PROJECT NO: 3030-02-72	HWY: STH 67	COUNTY: DODGE COUNTY	PROJECT OVERVIEW	SHEET	E
------------------------	-------------	----------------------	------------------	-------	---

PLAN DETAILS - STH 67

PROJECT NO: 3030-02-72	HWY: STH 67	COUNTY: DODGE COUNTY	PLAN DETAILS - STH 67	SHEET	E
------------------------	-------------	----------------------	-----------------------	-------	---

PROJECT NO: 3030-02-72	HWY: STH 67	COUNTY: DODGE COUNTY	DETOUR - STAGE 1-4	SHEET	E
------------------------	-------------	----------------------	--------------------	-------	---

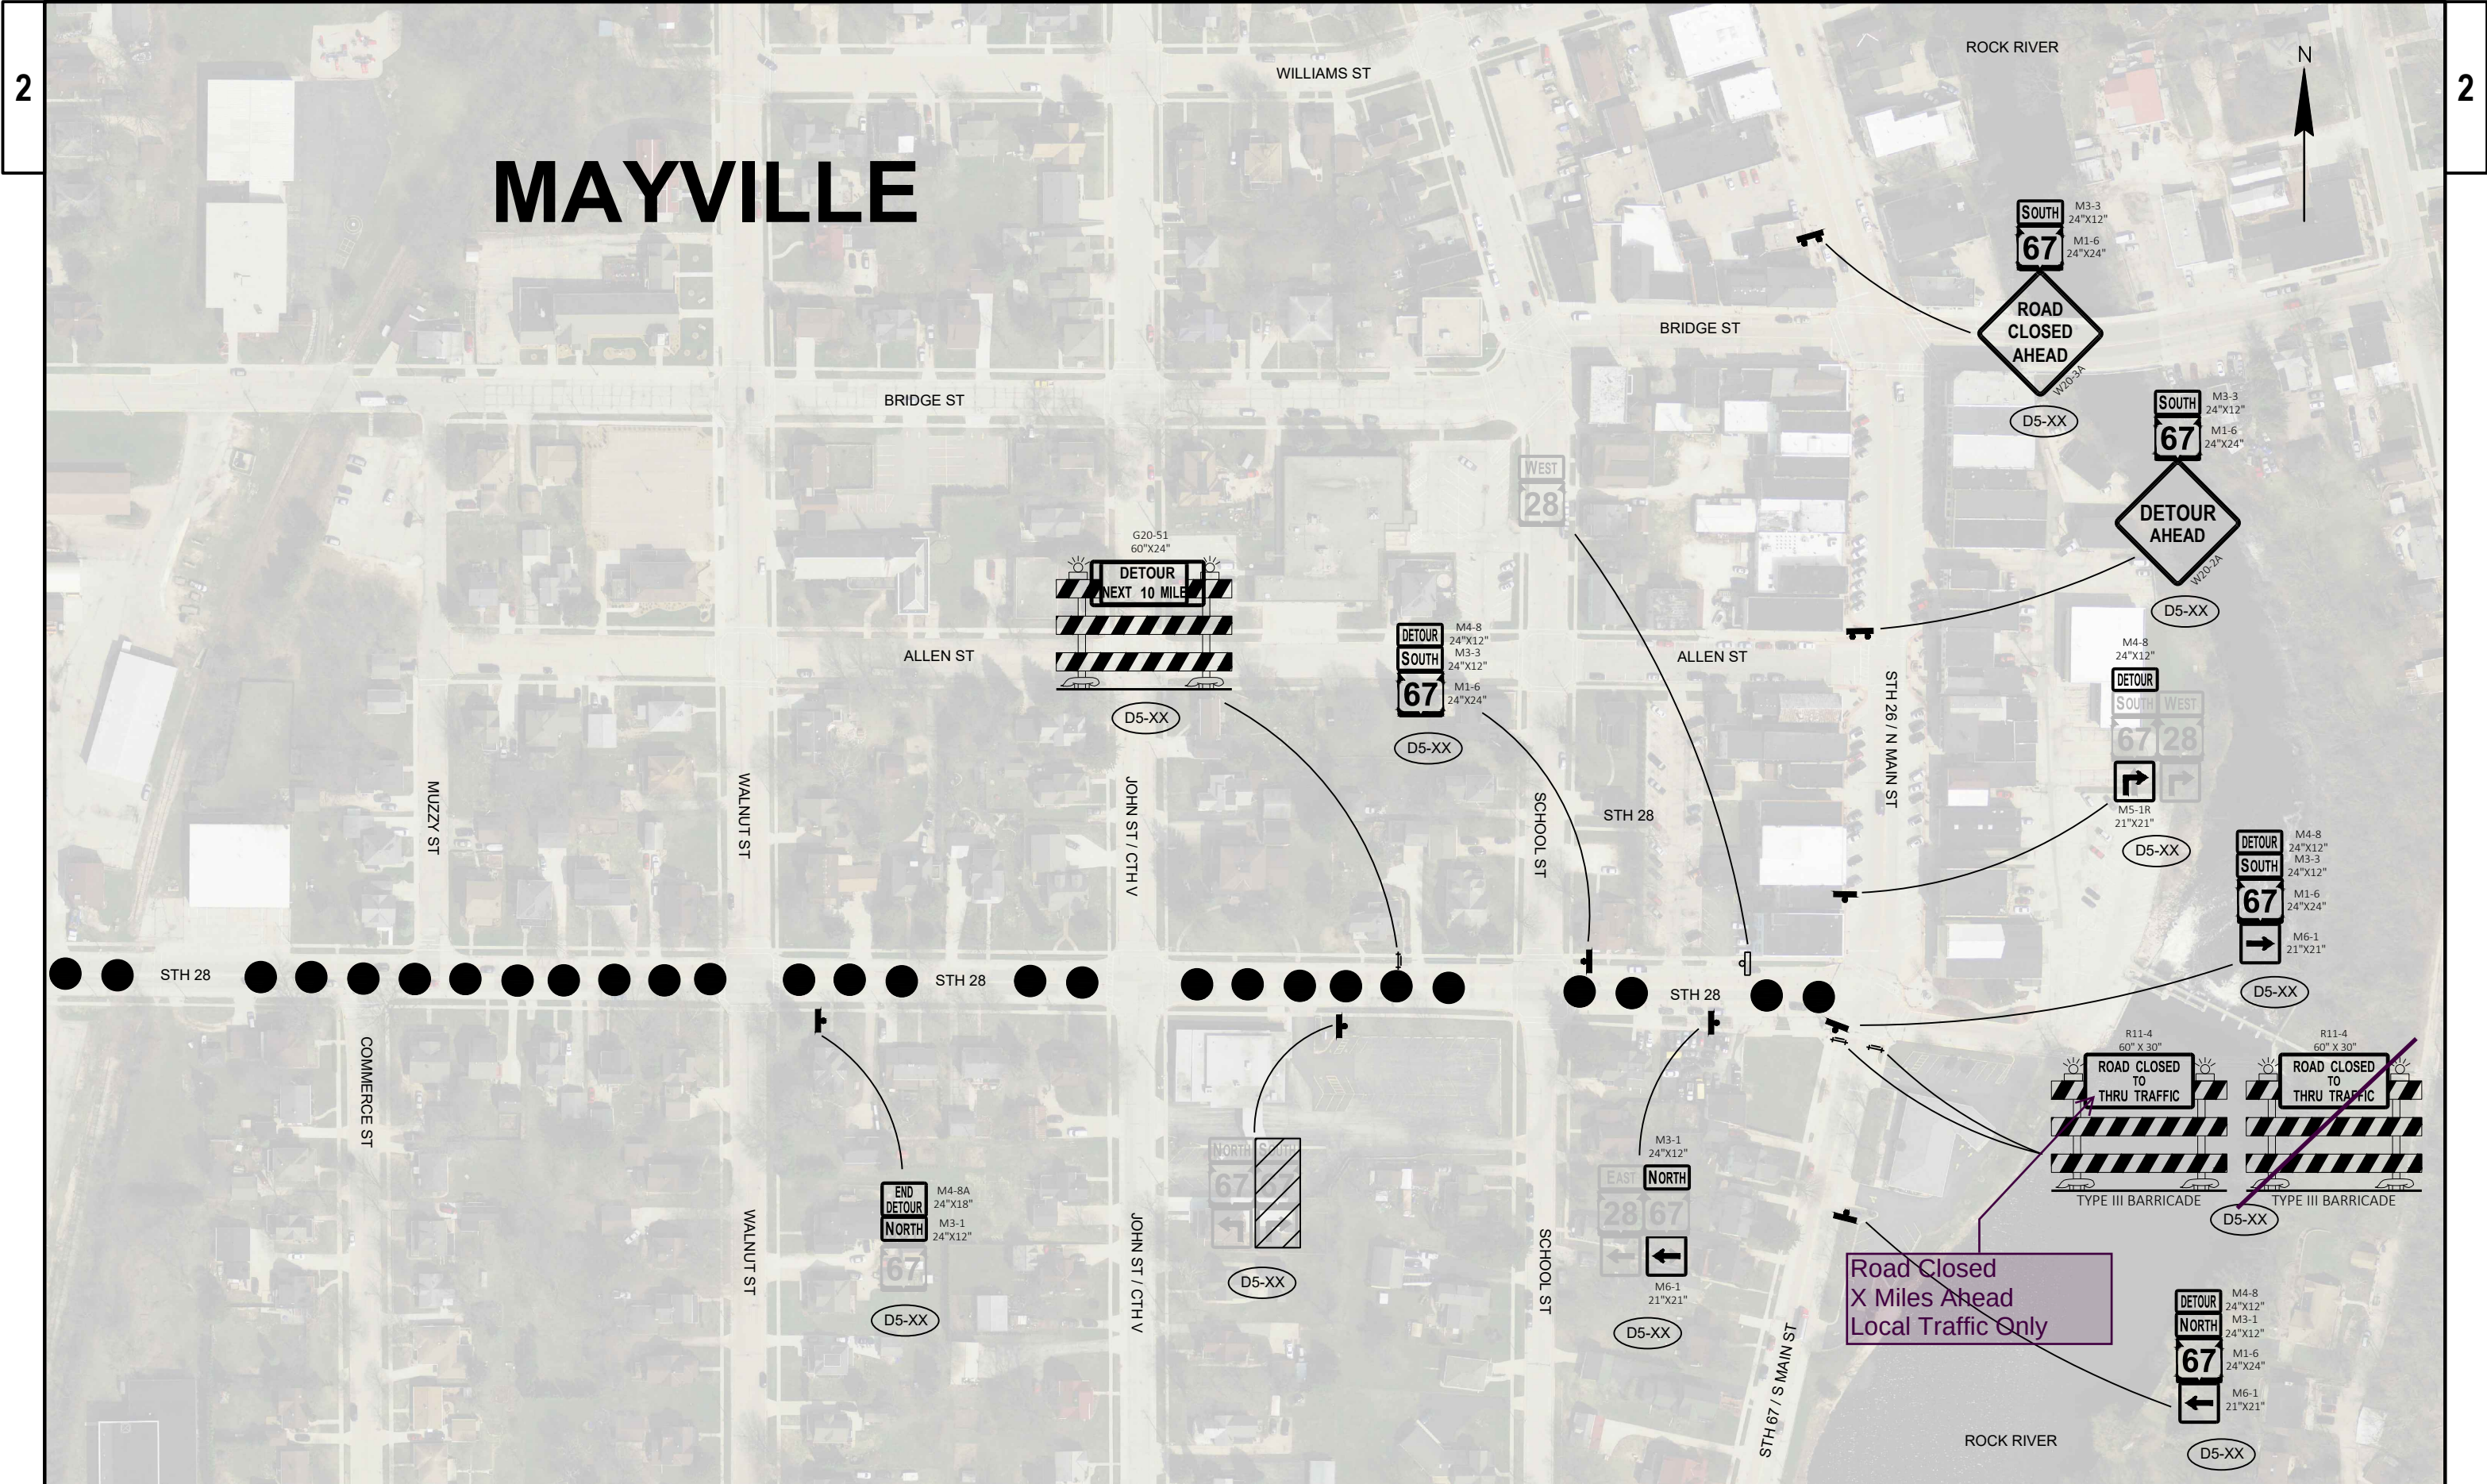
Dodge County Pete T. - We will approve the use of CTH S and CTH TW for the Stage 2 detour on STH 67 from CTH S to STH 33. Please review the route to if it will work for you.

I am positive the Stage 2 detour will become CTH S west to CTH TW north to STH 33. Not much can be done about it. Not many vehicles will follow the long detour. We may need to post the roads if it gets too bad. So at least the semis go around. I will ask the question here if we should allow the detour to be these 2 county highways. How long it Stage 2 scheduled?

Traffic had concerns with the County's proposed detour regarding the left turn from 33 to SB TW due to the lack of a turn or bypass lane. PDS looked at the relatively low ADT and duration of this segment again and determined it would be approximately 2 weeks and will plan to flag and build under traffic.
